Access Compliance Report

Public Rights-of-Way

(Curb Ramps)

Intersection ID: 49932	Main Street: WOBURN_RD	Cross Street: PAXTON_RUN_RD	Location: NW
ADA ID: B503EE28FC51	Ramp Type: Perp	Initial Pass/Fail: Pass	Overall Compliance: No
Severity Score: 5			
Codes/Mitigation Info/Possible Solution		Field Measurements/Component Compliance

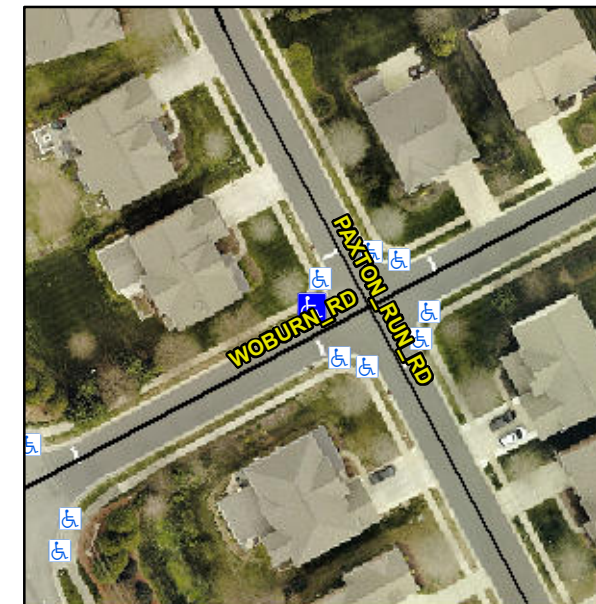
**Not Found, R304.2.2-Perp, R304.3.2-
Para, R302.7, R304.5.4**

Compliance	Description	Data	Compliance	Description	Data
N/A	Ramp Length (in)	47.0	Yes	Ramp Slope (%)	7.3
Yes	Ramp Width (in)	48.0	Yes	Ramp XSlope (%)	0.3
N/A	Flare Type LT	Sloped	N/A	Flare Type RT	N/A
N/A	Flare Slope LT (%)	8.6	Yes	Flare Slope RT (%)	6.4
N/A	Flare Traversable LT?	Yes	N/A	Flare Traversable RT?	Yes
Yes	Landing Length (in)	48.0	Yes	DWS Provided?	Yes
Yes	Landing Width (in)	48.0	Yes	DWS Contrast?	Yes
No	Landing Slope (%)	3.2	Yes	DWS Length (in)	24.5
Yes	Landing X Slope (%)	0.5	Yes	DWS Full Width?	Yes
N/A	Landing Curb? (Y/N)	No	Yes	DWS Offset (in)	2.0
N/A	Shared Landing?	No			
No	Gutter Ponding?	Yes	No	Gutter Slope (%)	5.3
Yes	Gutter Lip Ht (in)	0.0	Yes	Gutter X Slope (%)	0.2
N/A	Painted X Walk1?	No	N/A	Painted X Walk2?	N/A
	X Walk 1 Direction	To SE		X Walk 2 Direction	N/A
N/A	X Walk 1 Width (in)	N/A	N/A	X Walk 2 Width (in)	N/A
	X Walk 1 Slope (%)	1.3		X Walk 2 Slope (%)	N/A
	X Walk 1 X Slope (%)	1.1		X Walk 2 X Slope (%)	N/A

**Remove & Replace Entire Ramp.
Remove & Replace Gutter.**
